Product / Process Change Notification (PCN)

PCN Number: PCN_UtLAN_20240625

Affected Series: WE-LAN

4. Packaging change:

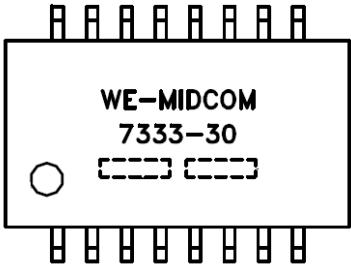
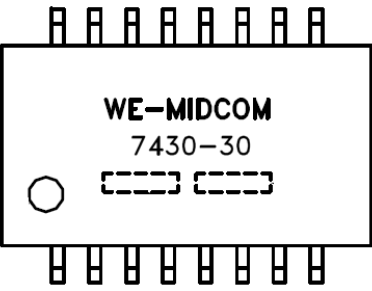
Affected part numbers: 749013011, 7490100143

Before Change	After Change
SPQ:	575 pcs	750 pcs
Carton Quantity:	2300 pcs	4500 pcs
Carton Length:	365 mm	395 mm
Carton Width:	342 mm	395 mm
Carton Height:	215 mm	240 mm

Affected part numbers: 749012011

Before Change	After Change
SPQ:	300 pcs	350 pcs
Carton Quantity:	1200 pcs	1750 pcs
Carton Length:	365 mm	395 mm
Carton Width:	342 mm	395 mm
Carton Height:	253 mm	240 mm

6. Dimension changes

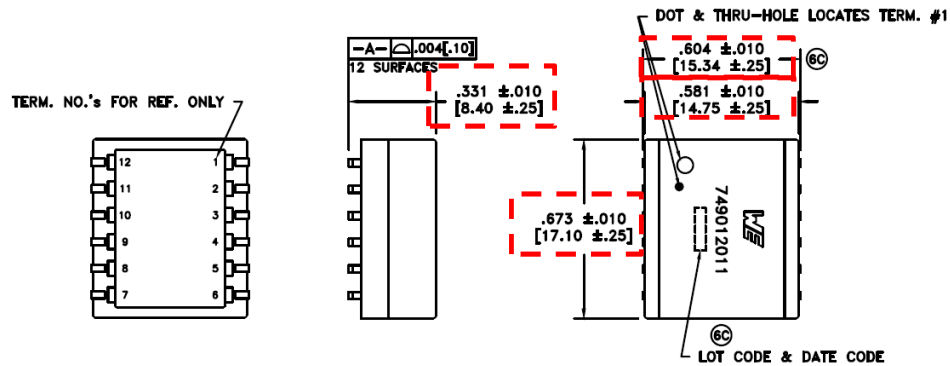
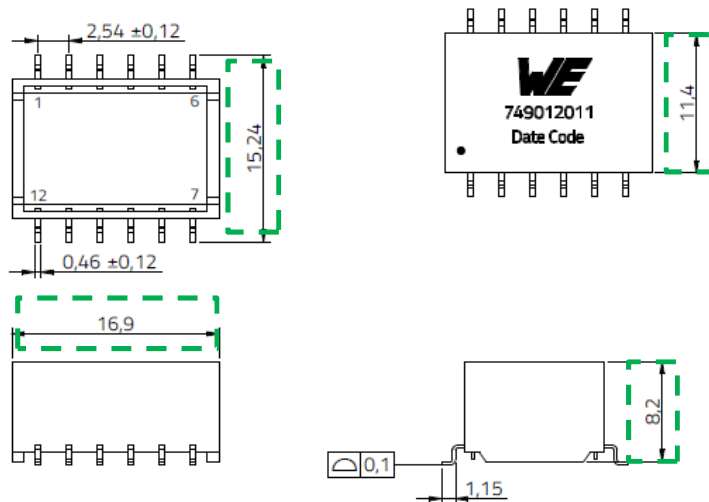
Affected part numbers: 749012011

Before change:

After change:
